Reference: Weber State University  
Shepherd Union Building Renovation & Remodel  
DFCM Project No. 03215810

Subject: **Addendum No. 1**

**Addendum No. One  
for the  
WSU Shepherd Union Building Renovation  
Demolition & Abatement  
DFCM Project No. 03215810  
MHTN Project No. 2005556**

ARCH REF:  
**ADD  
1.06**

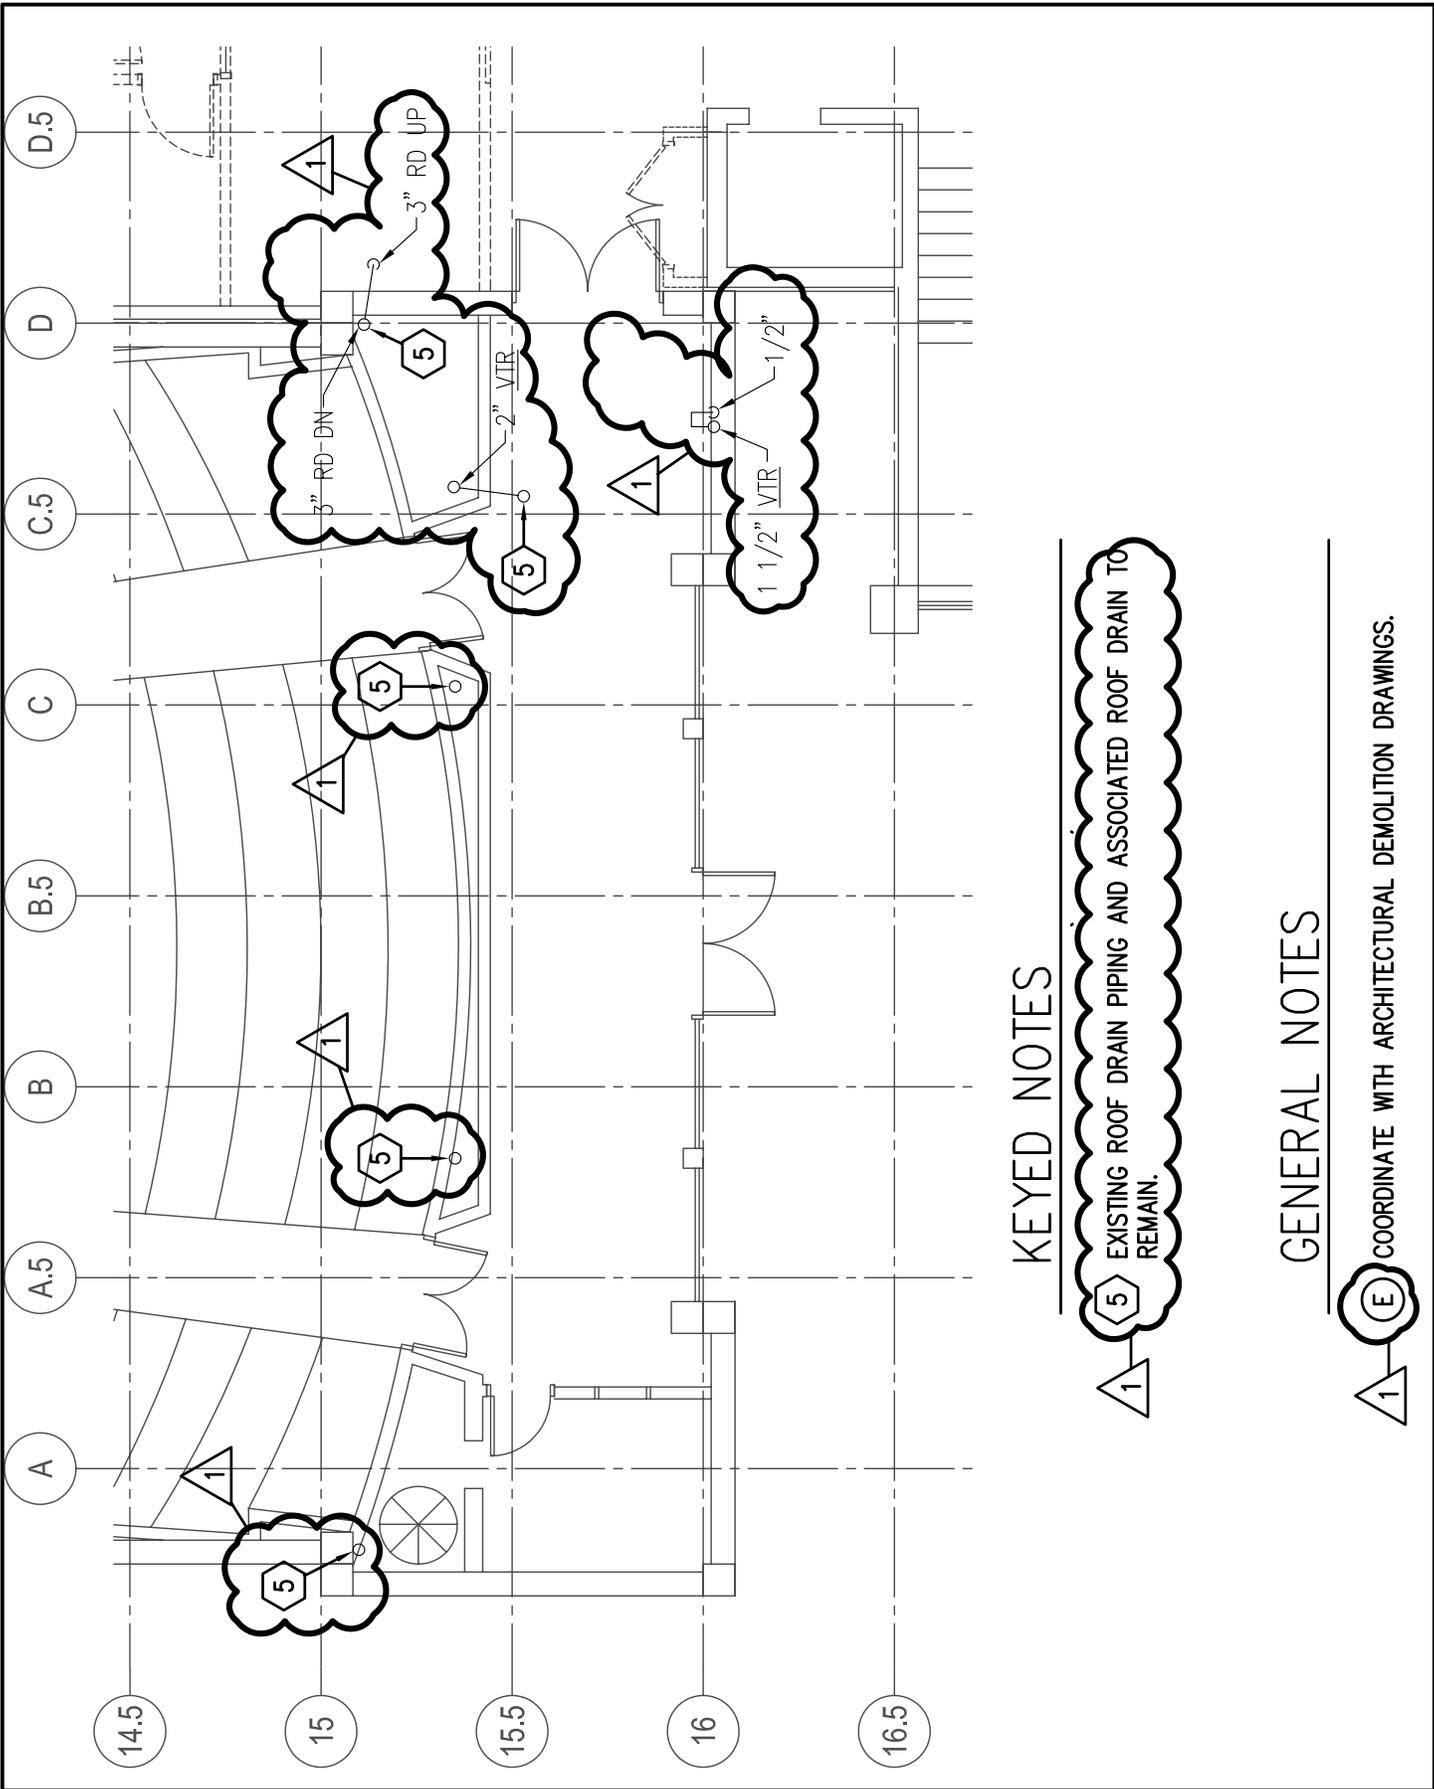
Sheet Title:  
**ADDENDUM #1  
REMOVED OLD DIFFUSER CALLOUT**

ARCH REF:  
**ADD  
1.07**

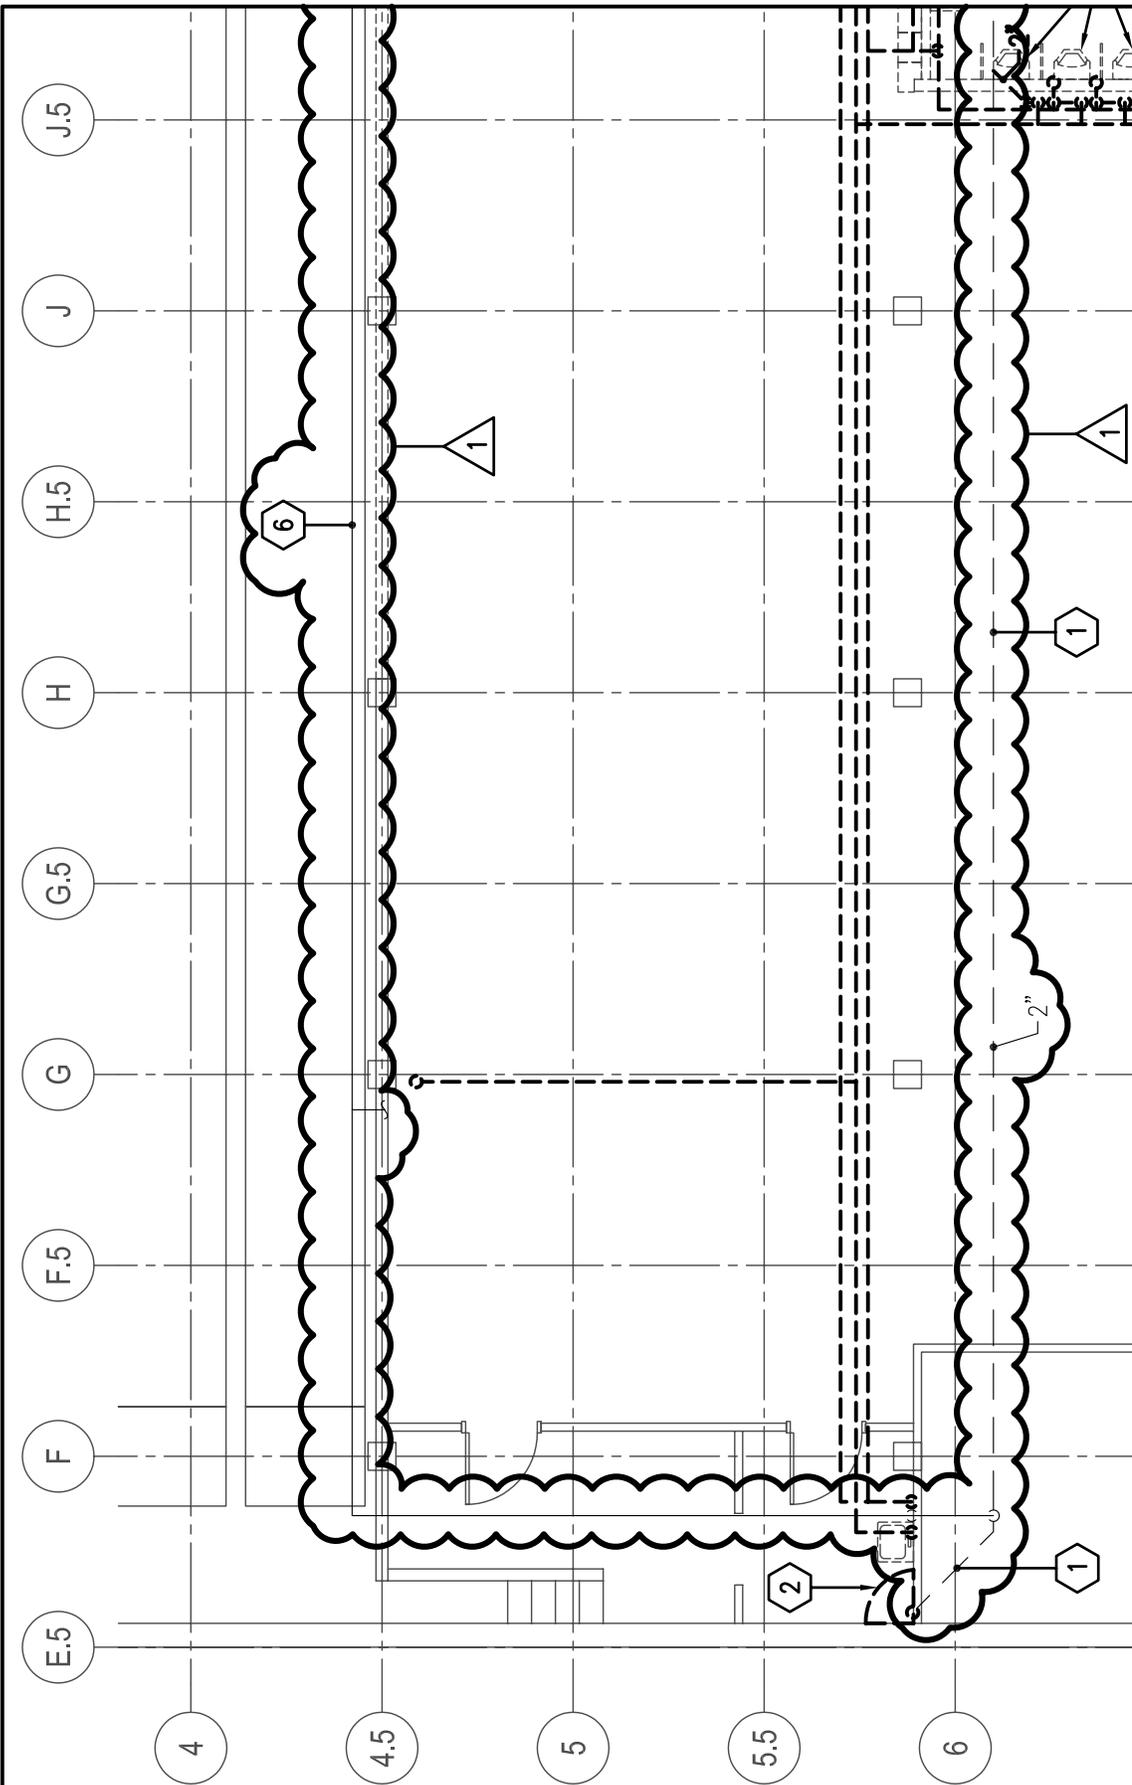
1  
E  
COORDINATE WITH ARCHITECTURAL DEMOLITION DRAWINGS.

Sheet Title:  
**ADDENDUM #1  
GENERAL NOTE CLARIFICATION**  
**Colvin Engineering Associates, Inc.**  
244 West, 300 North, Suite 200 / Salt Lake City, Utah 84103-1108  
(801) 322-2400 / Fax (801) 322-2416

**ADD  
 1.08**

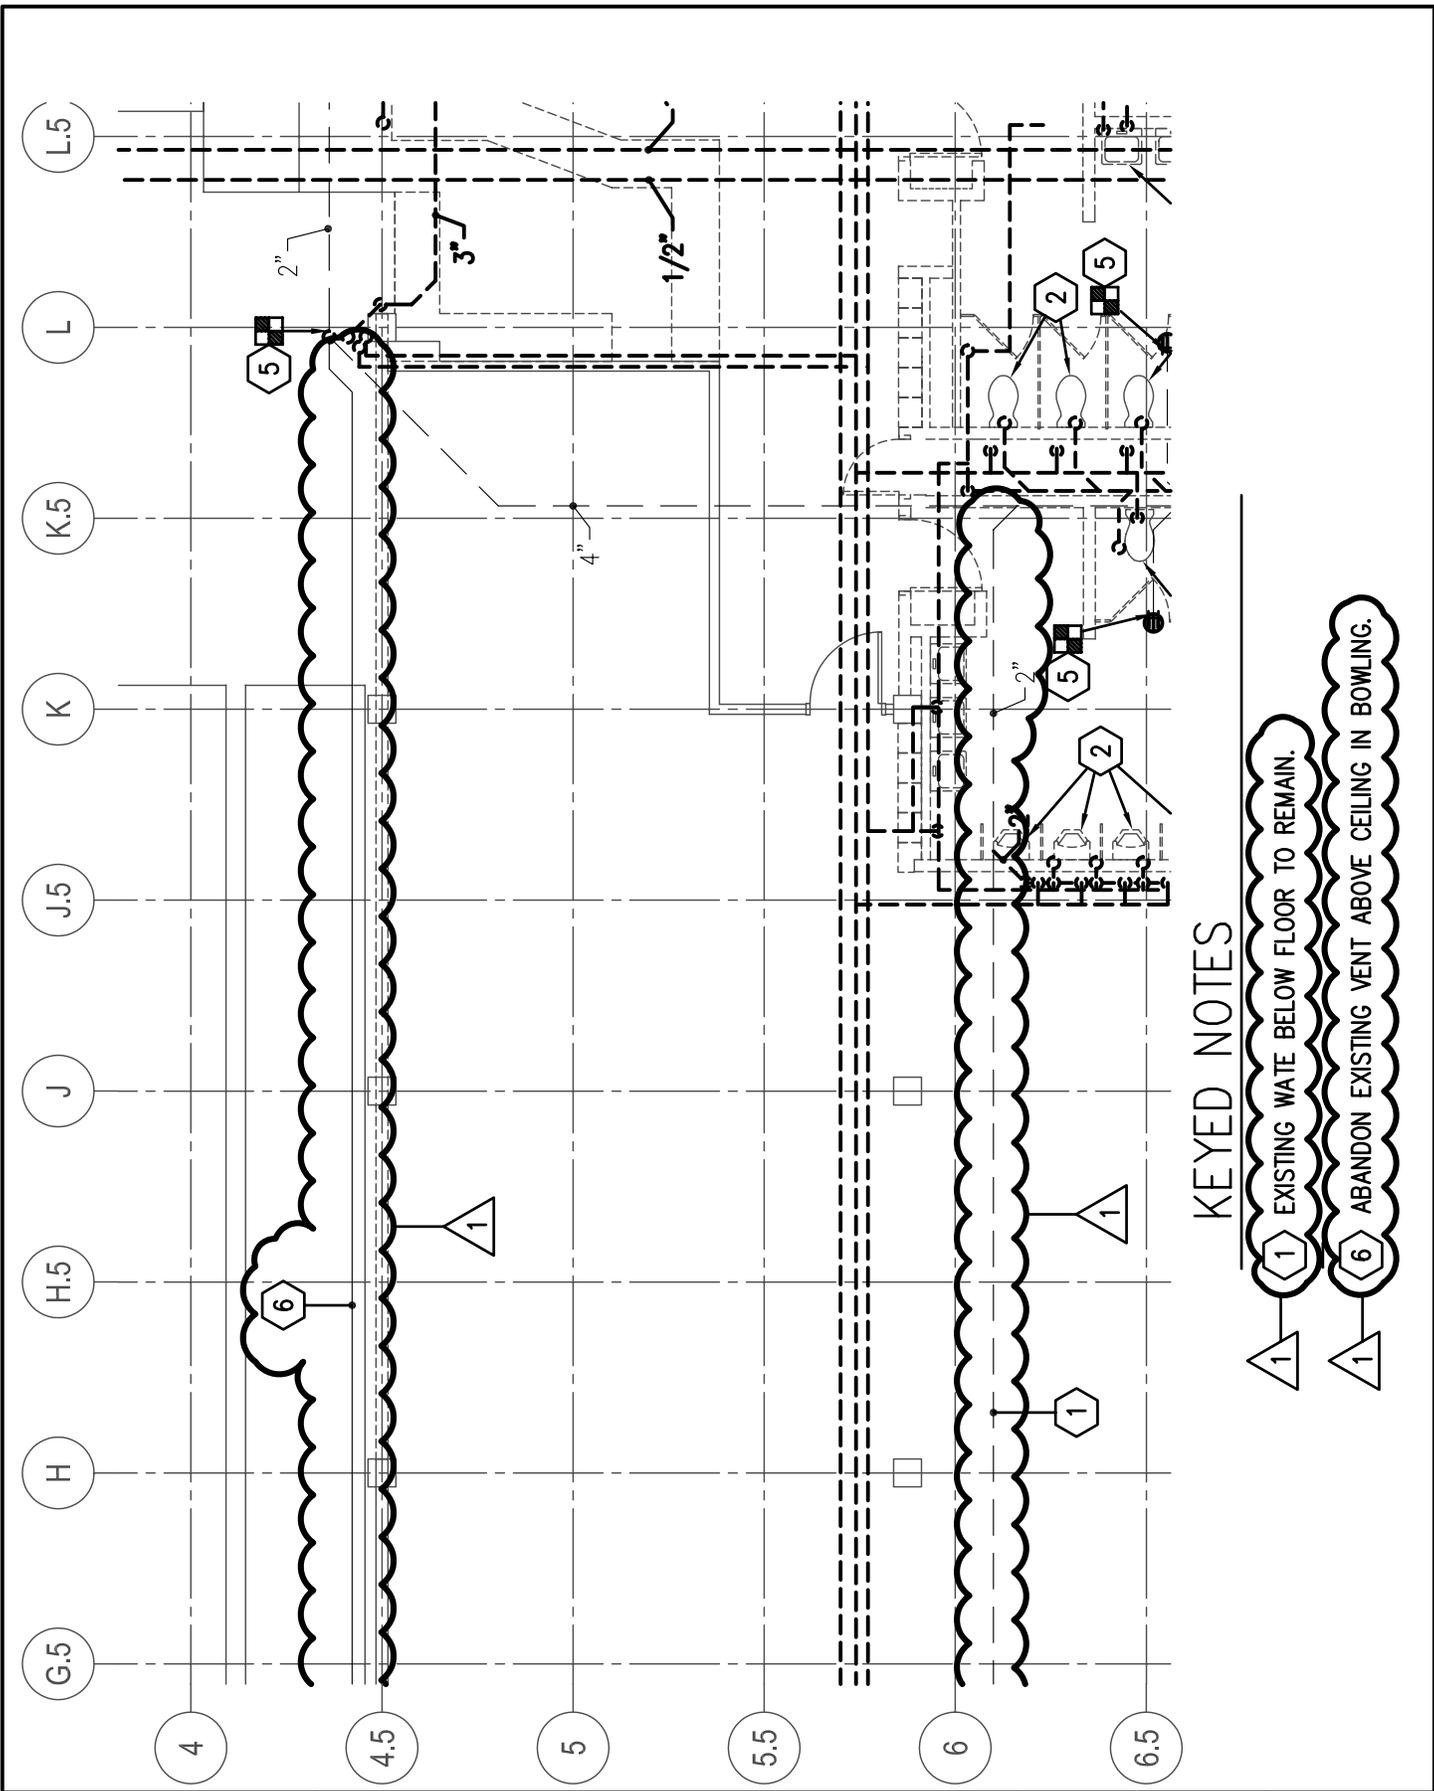
Sheet Title:  
**ADDENDUM #1  
 2" UNDERGROUND WASTE TO REMAIN**

- 1 EXISTING WASTE BELOW FLOOR TO REMAIN.
- 6 ABANDON EXISTING VENT ABOVE CEILING IN BOWLING.

ARCH REF:  
**ADD  
 1.09**

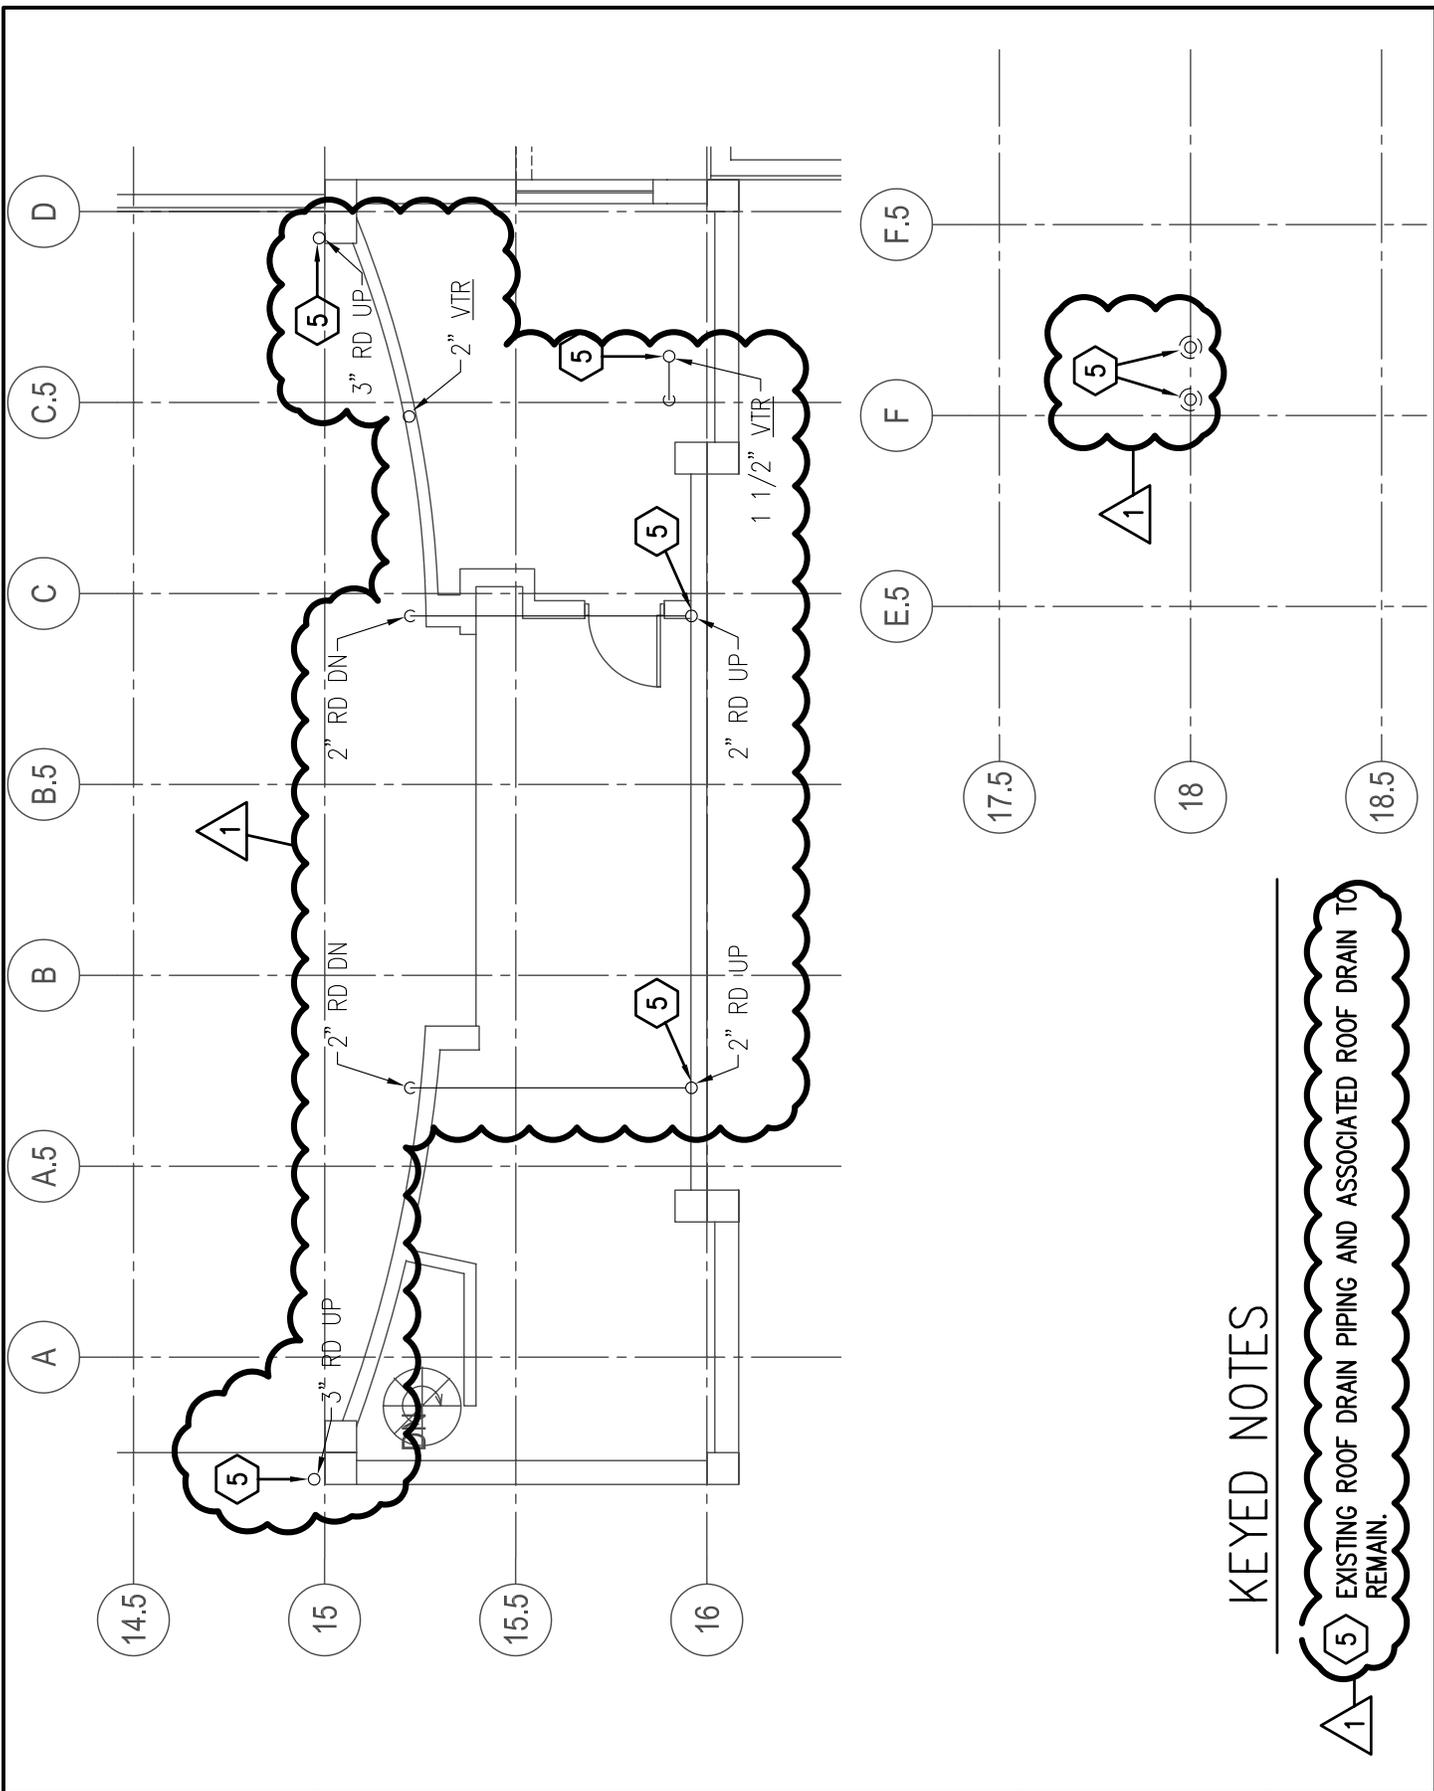
Sheet Title:  
**ADDENDUM #1  
 2" UNDERGROUND WASTE TO REMAIN**

ARCH REF:  
**ADD  
 1.10**

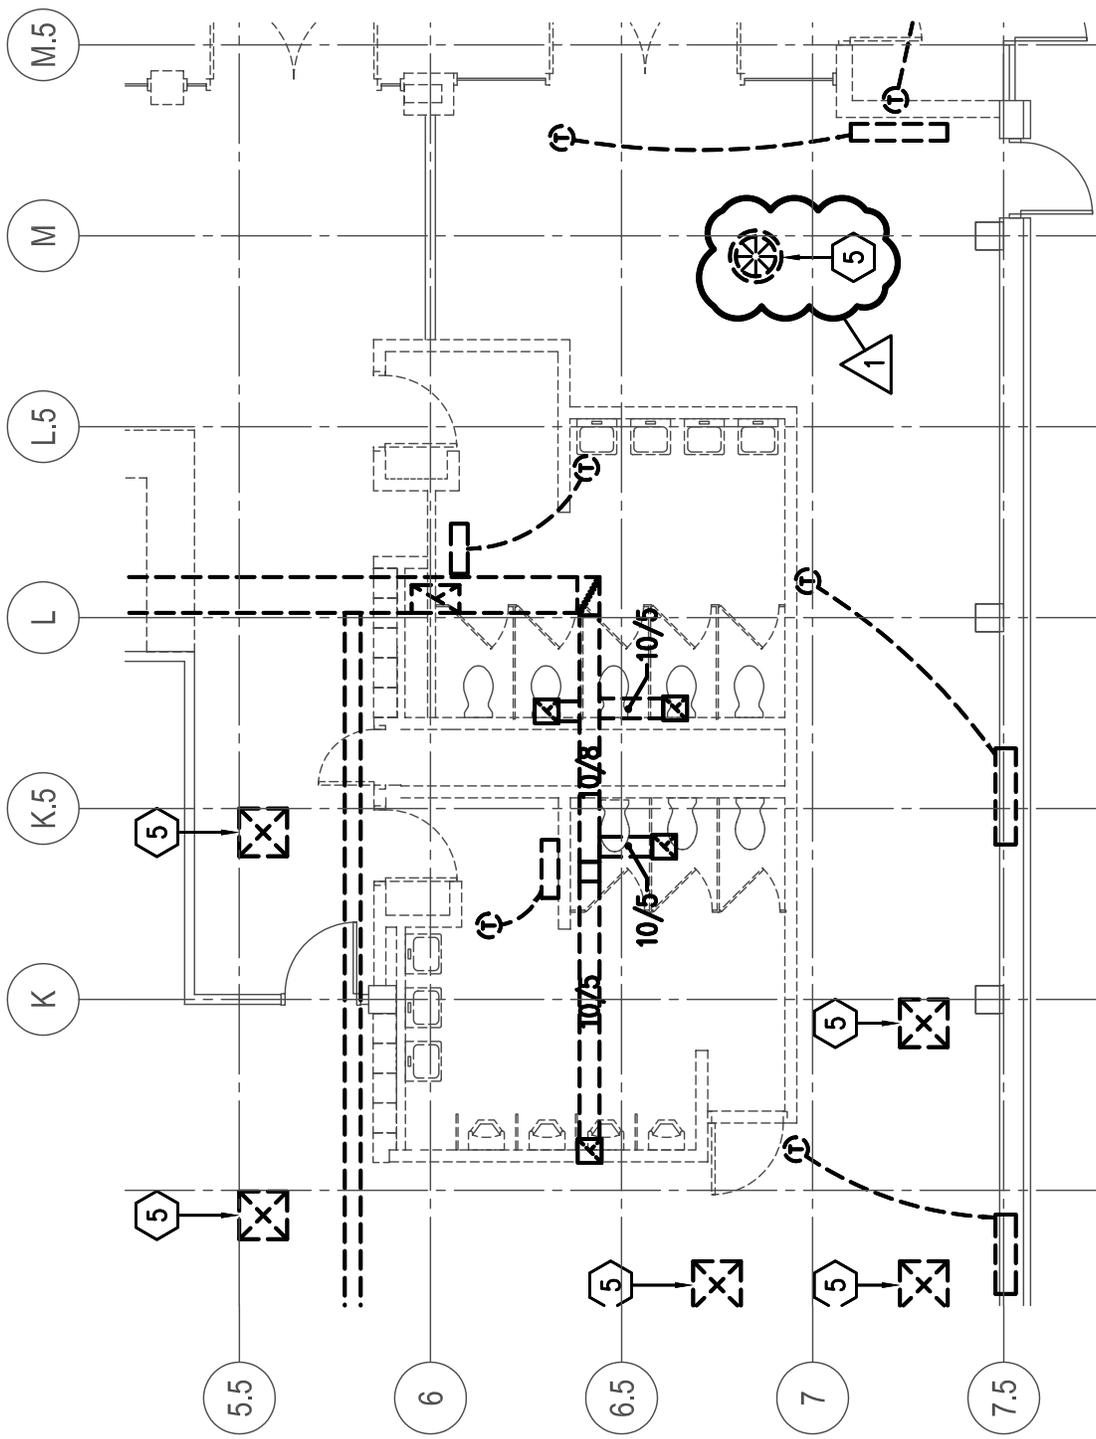
5 EXISTING ROOF DRAIN PIPING AND ASSOCIATED ROOF DRAIN TO REMAIN.

Sheet Title:  
**ADDENDUM #1  
 PLUMBING TO REMAIN**  
**Colvin Engineering Associates, Inc.**  
 244 West, 300 North, Suite 200 / Salt Lake City, Utah 84103-1108  
 (801) 322-2400 / Fax (801) 322-2416
